# Ventura County Community College District

DATE: 11/04/26
TO: All Bidders
FROM: David Cienfuegos, Purchasing Specialist
SUBJECT: Addendum 1 – Bid 743 Moorpark College Student Service Annex Exterior Door Replacement

**Attached please find revised Drawing & Specs for this project, Bid 743_DWG_Addendum 01_2026-10-08**

**DOOR REPLACEMENT STUDENT SERVICES (SS) BUILDING**

**A102**

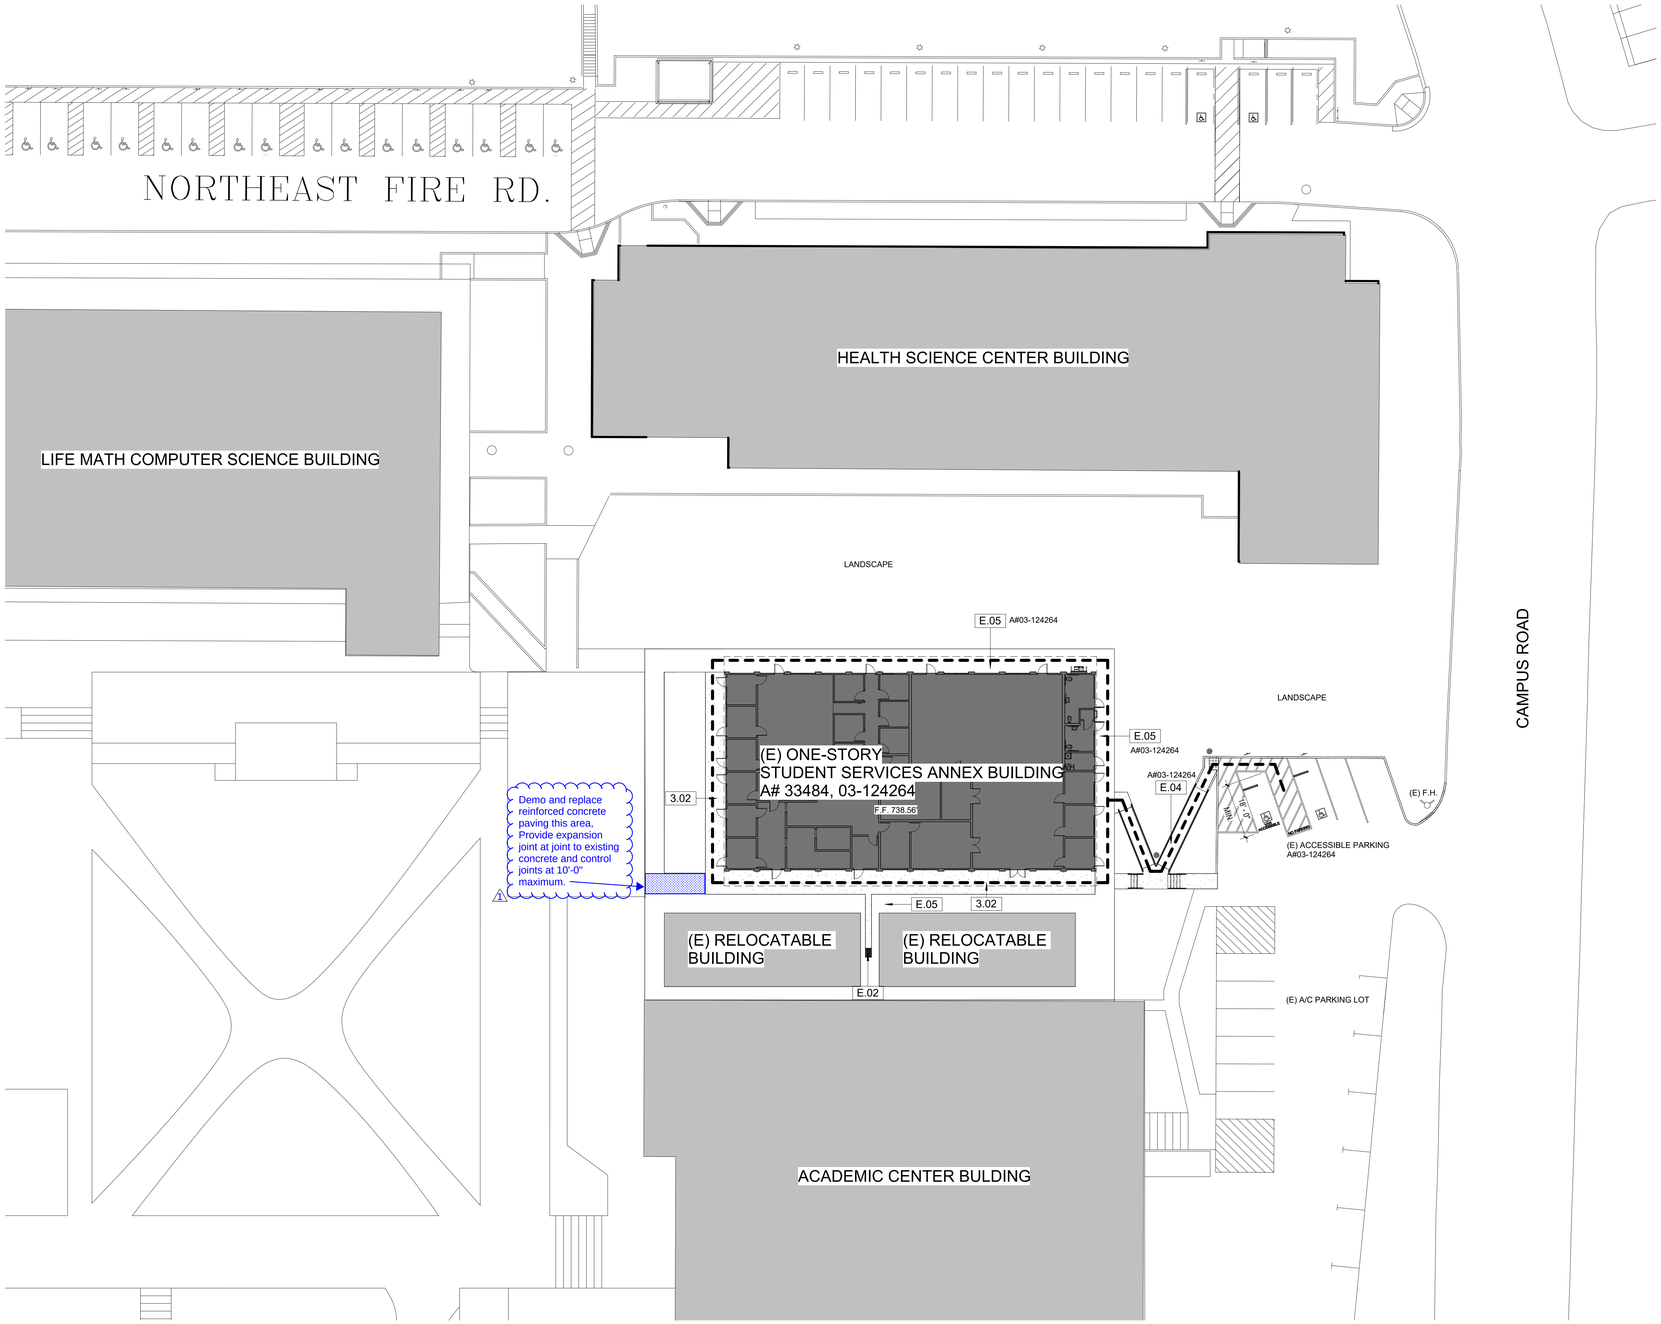
**A102** – SITE PLAN: Add concrete pavement removal and replacement as noted

**A105**

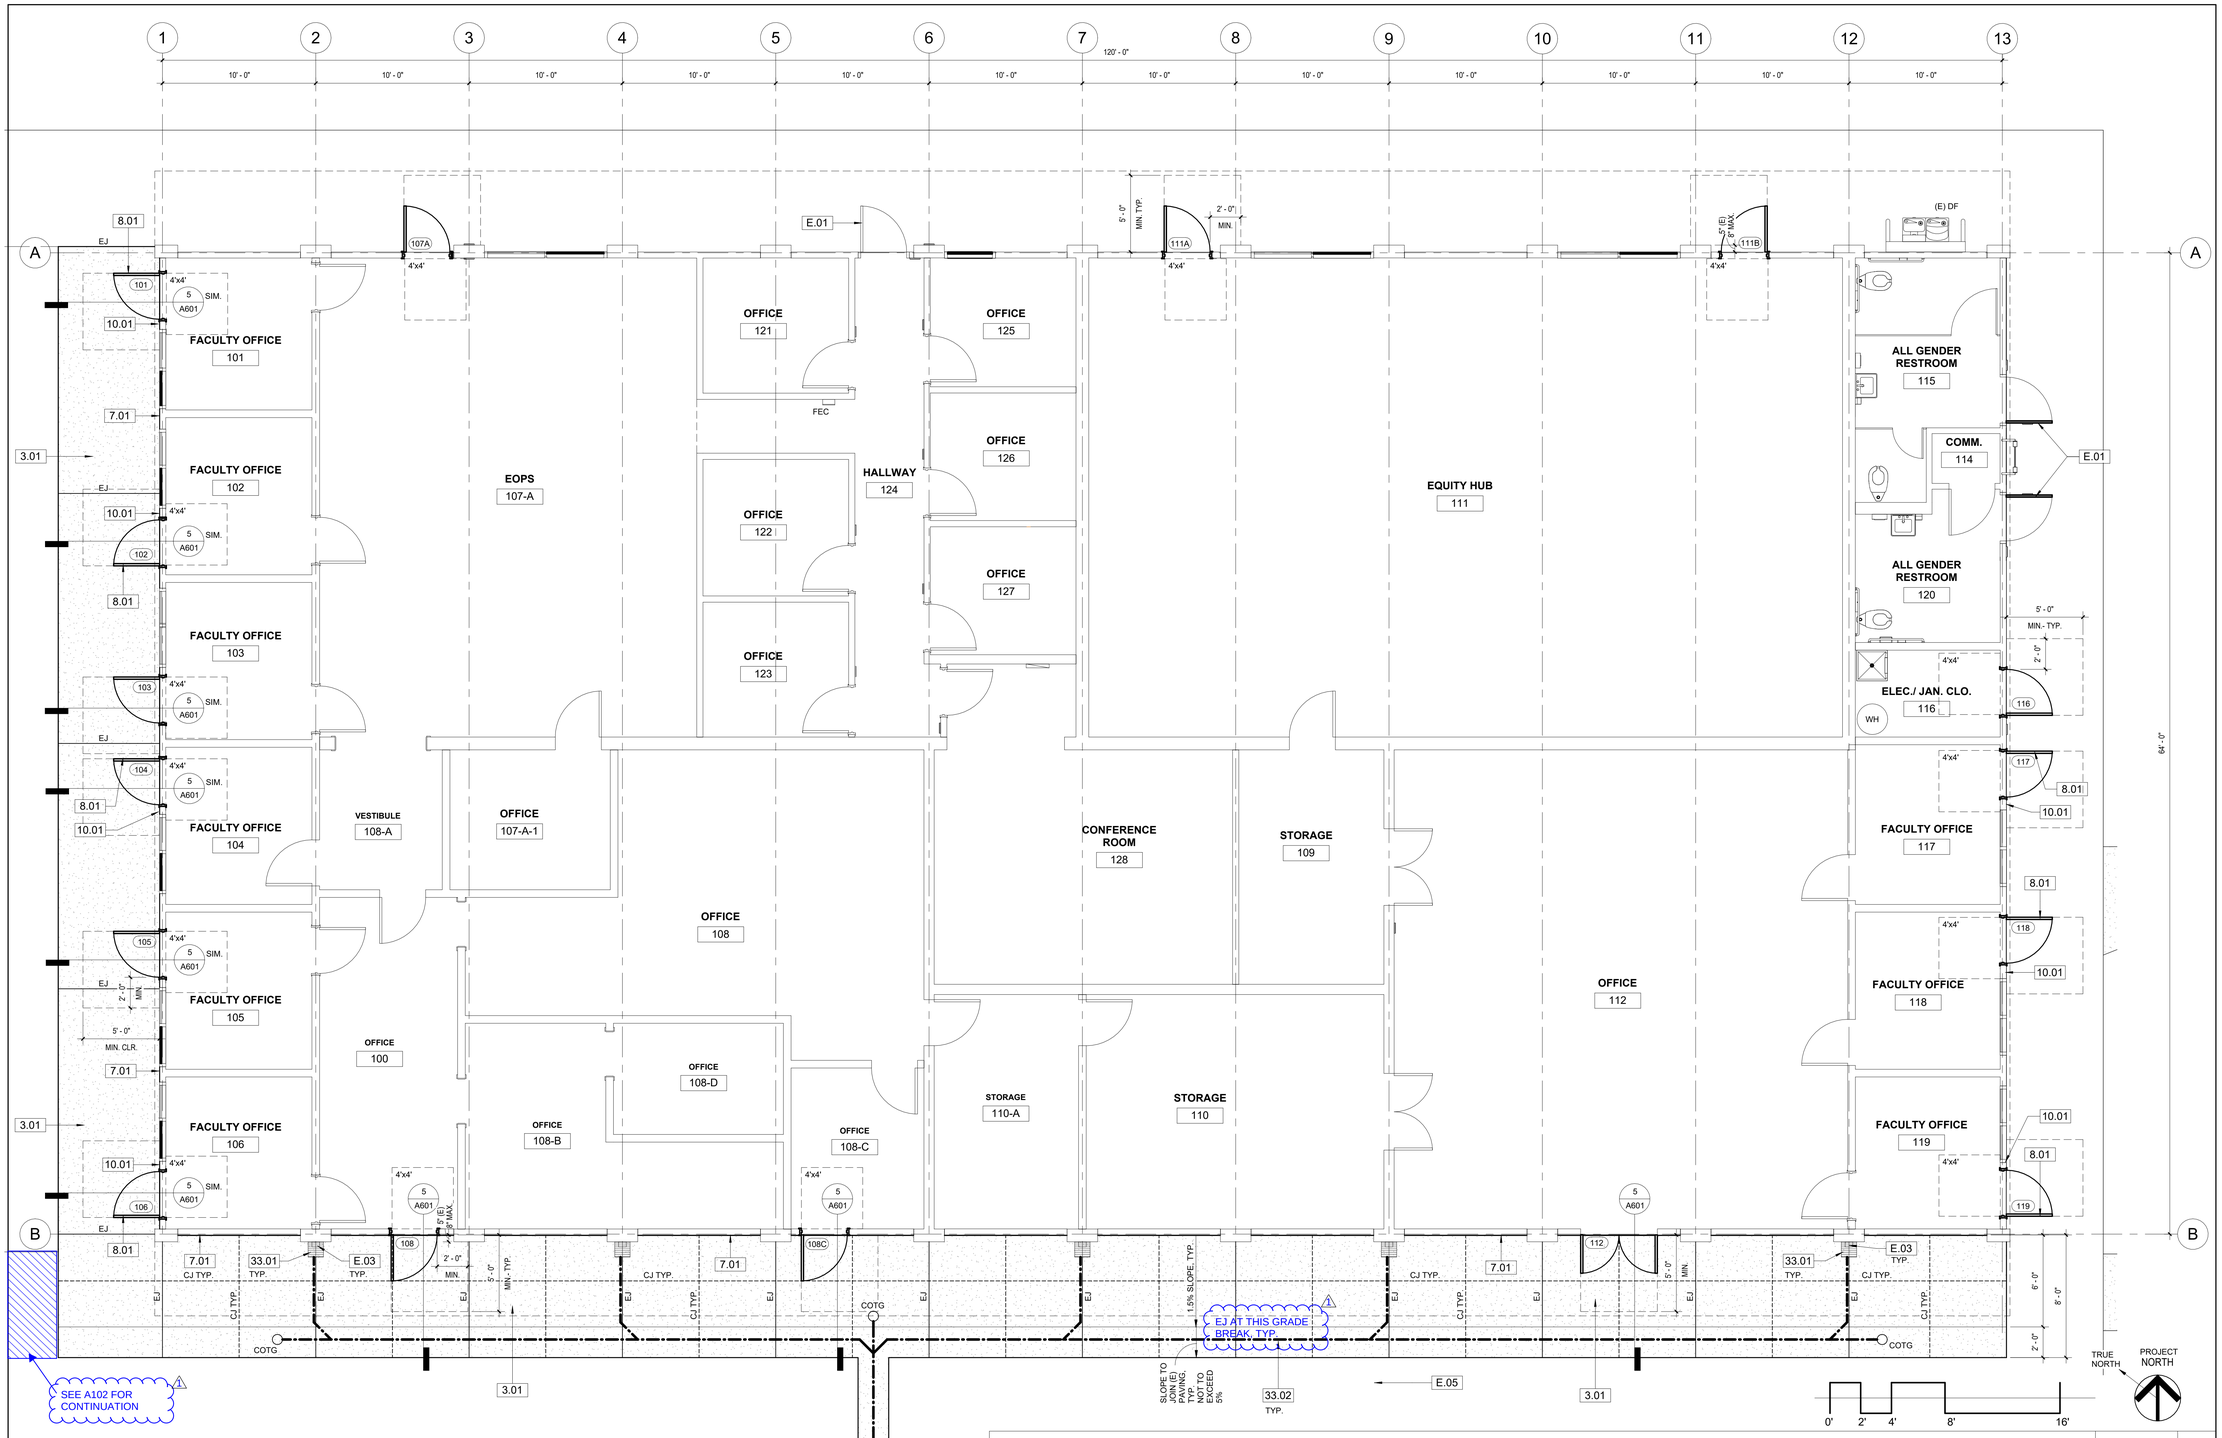
**A105** – DEMO FLOOR PLAN: Additional concrete demolition noted.
